COUNTY OF FAIRFAX, VIRGINIA

Case No. C-203 In the name of GULF RESTON, INC.

STAFF REPORT

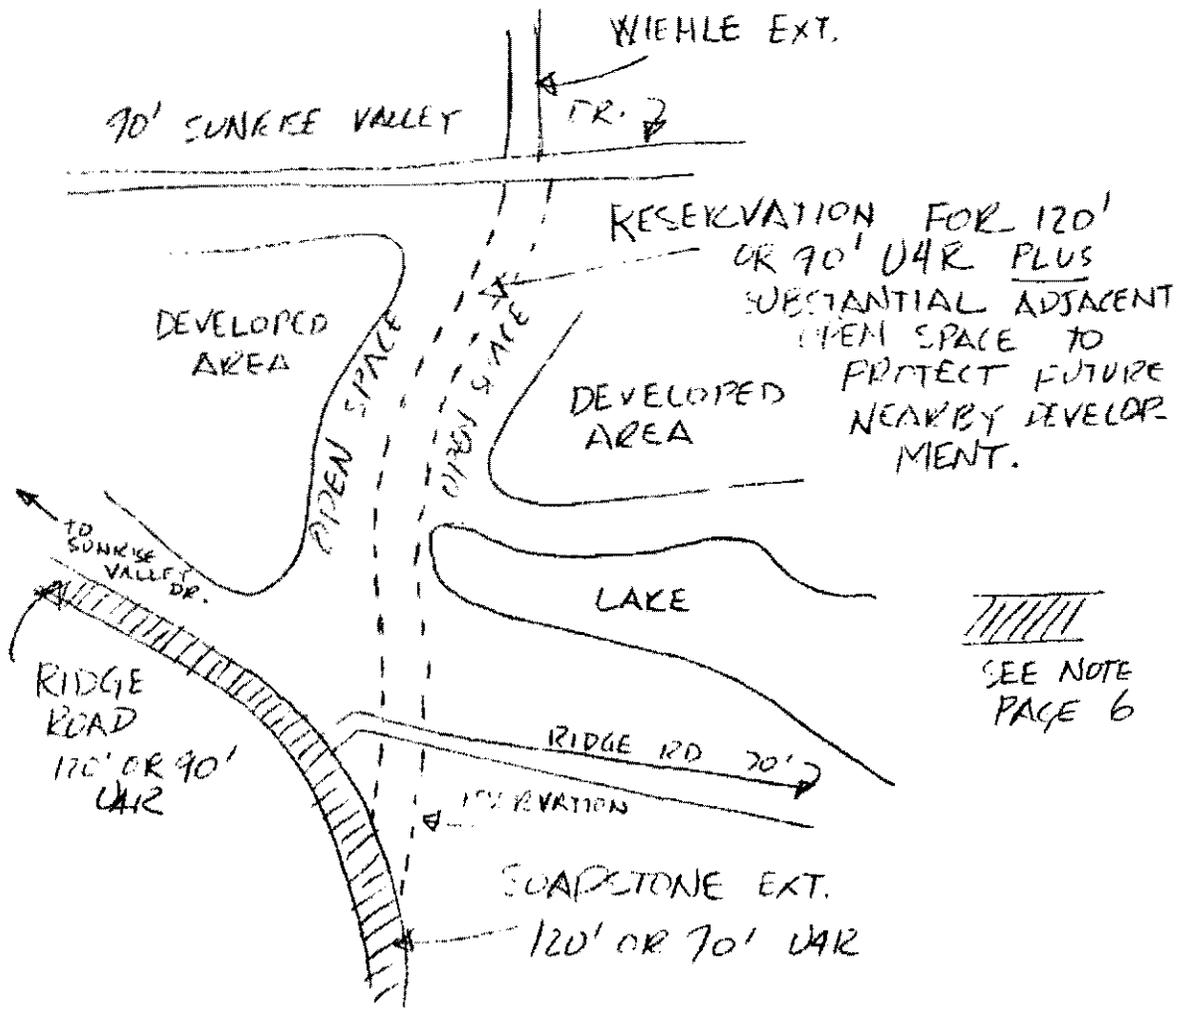
The staff has reviewed the subject application and finds that it is in accord with the principles expressed for the development of Reston. The position of the staff with respect to the question of the connection of Soapstone Drive and Wiehle Avenue is that it should be constructed and dedicated at the time of the development of the area. This position is based on the information contained in the Urban Needs Study and in the Reston Transportation Plan. The right of way of 120 ft. should be dedicated to the Board of Supervisors. An alternative acceptable to the staff would be the dedication of a 90 ft. right of way and the construction of a U4R cross-section. Adoption of this proposal by the Board of Supervisors would necessitate a certain amount of redesign of the development plan to reflect the change. Specifically, the addition of the road should not have the effect of removing any open space and certainly should not impair the pedestrian walkway system.

This proposal is illustrated in the diagram below.

However, should this staff proposal be rejected, provision should be made for the accommodation of the traffic needs which would otherwise have been met by the facility. This alternative would include construction and dedication of Soapstone Drive from the southern edge of the development northward, thence continuing in an acceptable curvature into and along Ridge Road; the entire road should be a minimum 120 ft. right of way from the southernmost point to Sunrise Valley Drive, although the option of a 90 ft. U4R cross-section would be acceptable. The diagram below shows this alternative.

Note that the staff has shown significant amounts of open space along the right of way to be reserved. This is to ensure that the facility when constructed will not have an adverse impact on adjacent development.

That C-203 for RFE be granted and that the development plan be approved subject to its modification to reflect the changes recommended above.
